Review 3

Mahalaxmi Bayonne Urban Renewal, LLC
General Development Plan Amendment

Application P-23-017
Harbor Station South Redevelopment Area (HS-2 District)
One Flagship Street
Block 751, Lots 1.11, 1.14, and 1.15

February 11, 2025

Figure 2. GDP Application Diagram

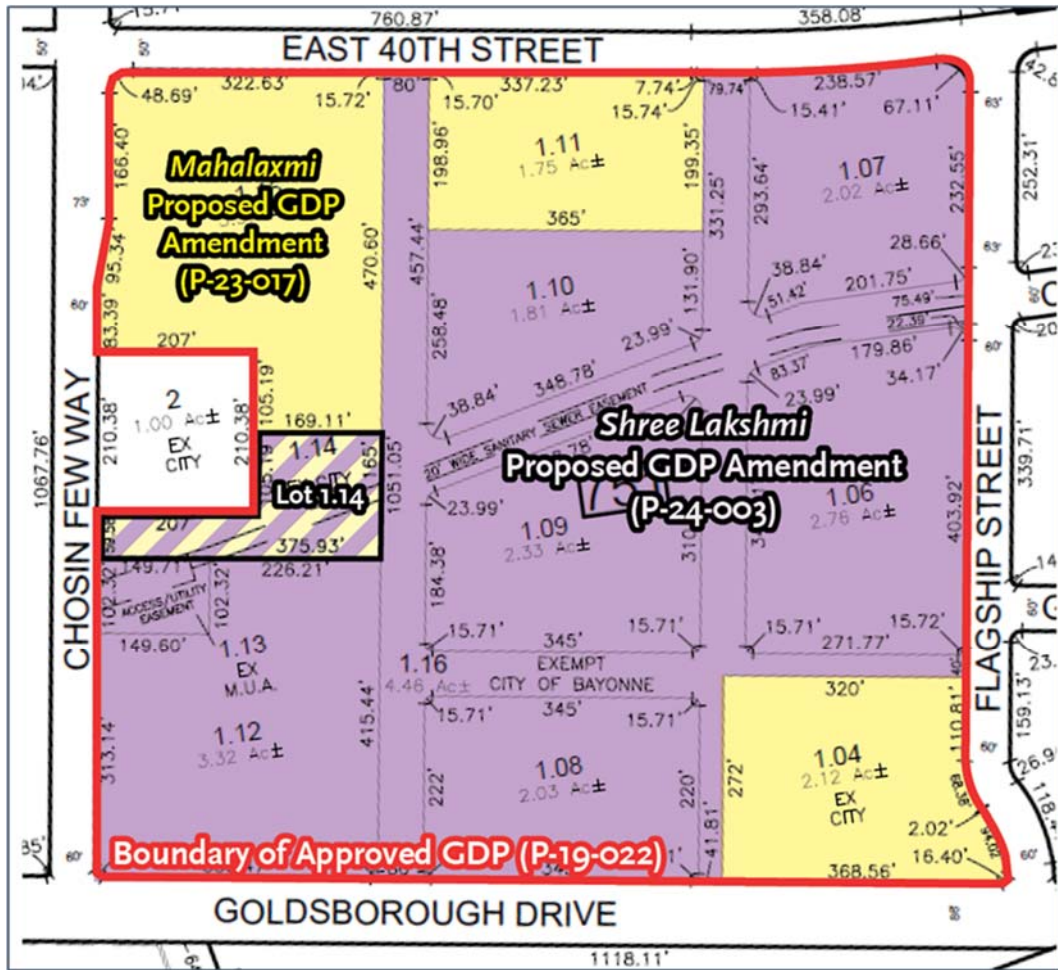
- 1.4.1. Lot 1.13 and Lot 2 are Not included in Either GDP Amendment.** Both lots are City-owned. Lot 1.13 was originally intended for utility use and Lot 2 is where the fire station is located. Since what is proposed are amendments, it means that what is being amended is the large majority of the original GDP, but not its entirety. **Any conditions, terms, obligations, bonding, phasing or other responsibilities with respect to these two lots from the original GDP will need to remain in full force and effect with any approved amendment.**

- 1.4.2. Lot 1.14 is Double Counted.** Both applications for GDP amendment include Lot 1.14 in their open space calculations. The lot is owned by the City of Bayonne. **Lot 1.14 should be removed from this application unless it is removed from the Shree Lakshmi GDP application (P-24-003).**

Lot 1.04 as indicated in the proposed amended GDP. The light gray area of the building has been developed.

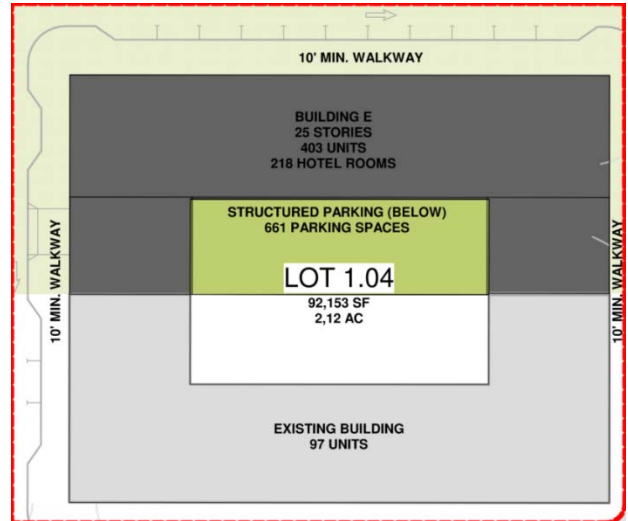
3.3.1. **Lot 1.04.** Lot 1.04 is the only parcel within the GDP that has been developed. An existing five story building with 97 units and 97 parking spaces³ was developed pursuant to a prior Board approval. Next to the building at its rear, “Building E” is indicated for future development, containing a 25-story building with 403 residential units and 218 hotel rooms, served by 661 parking spaces, that would be attached to the existing building to create one larger structure. Lastly, 3,120 sf. of commercial space is either proposed, existing, or would be a combination of both conditions. This is a change

from the original GDP. The original GDP included the 97-unit building, but the rear portion was originally indicated as “Building A2” and was intended to contain 12 stories with 272 residential units and 107 parking spaces. Additionally, this parcel was slated for 12,769 sf. of commercial space. **It is unclear from the GDP how the proposed amendment will affect the existing surface parking lot and the area between the existing building and proposed Building E.**

Lot 1.11 (above) and Lot 1.14 (next page) as indicated in the proposed GDP.

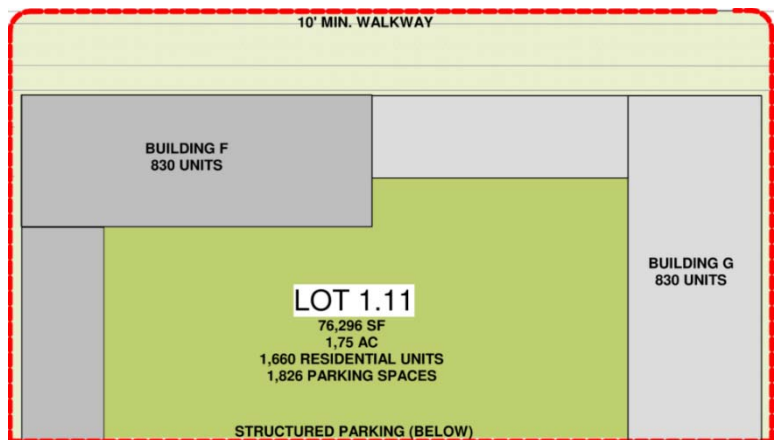
3.3.2. **Lot 1.11.** Two buildings and structured parking are proposed on Lot 1.11. It consists of Buildings F and G, both of which are 50-story towers containing 830 residential units (for a total of 1,660 residential units). A parking structure is also proposed containing 1,826 parking spaces. The “Commercial Area Summary” table located on sheet 3 of the GDP indicates that Lot 1.11 will contain 6,229 sf. of commercial space. This is a change from the original GDP. The original GDP included a 10-story building labeled “Building D3” with

207 residential units on Lot 1.11. Additionally, a 76,296 sf. parking structure was proposed.

3.3.3. **Lot 1.14.** Lot 1.14 is proposed to contain a public park encompassing the entirety of the parcel totaling 0.92 acre (40,246 sf.). This appears to be in line with the original GDP which was indicated as a “Park Lot” and encompassed the same area. **This lot is included in another application as noted elsewhere in this report.**

Lot 1.15 as indicated in the proposed GDP. Building A (dark gray) received site plan approval.

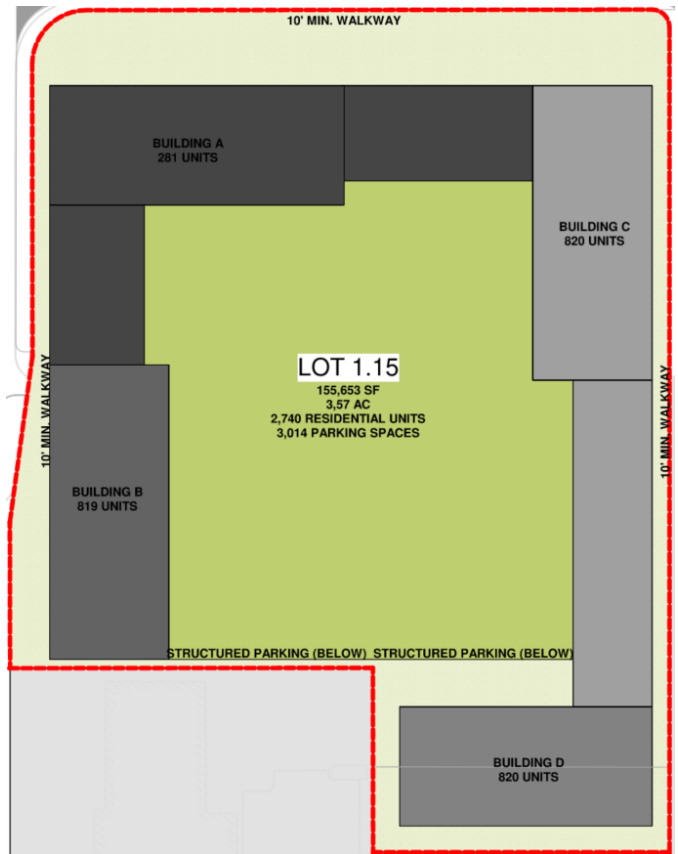
3.3.4. **Lot 1.15.** Lot 1.15 is proposed to contain four buildings, indicated as Buildings A, B, C, and D. the size of the lot is 3.57 acres. Building A was the subject of an approved site plan application in 2023. Building A is 26 stories and has 281 residential units. Building B is 50 stories and 819 units. Building C is 50 stories with 820 residential units, and Building D is 50 stories and contains 820 residential units. The total number of proposed residential units is 2,740. The GDP indicates there will be 3,014 total parking spaces in structured parking, though the configuration of the parking is unknown outside of the already approved Building A. The “Commercial Area Summary” table located on sheet 3 of the GDP plan indicates that Lot 1.15 will contain 15,383 sf. of commercial space.

This is a change from the original GDP. As detailed at the time of site plan application for Building A, the GDP previously contained a 10-story hotel with 218 rooms, two eight-story buildings with 91 residential units and 117 residential units, a six-story parking garage with 567 parking spaces, and a surface parking lot with 89 parking spaces.
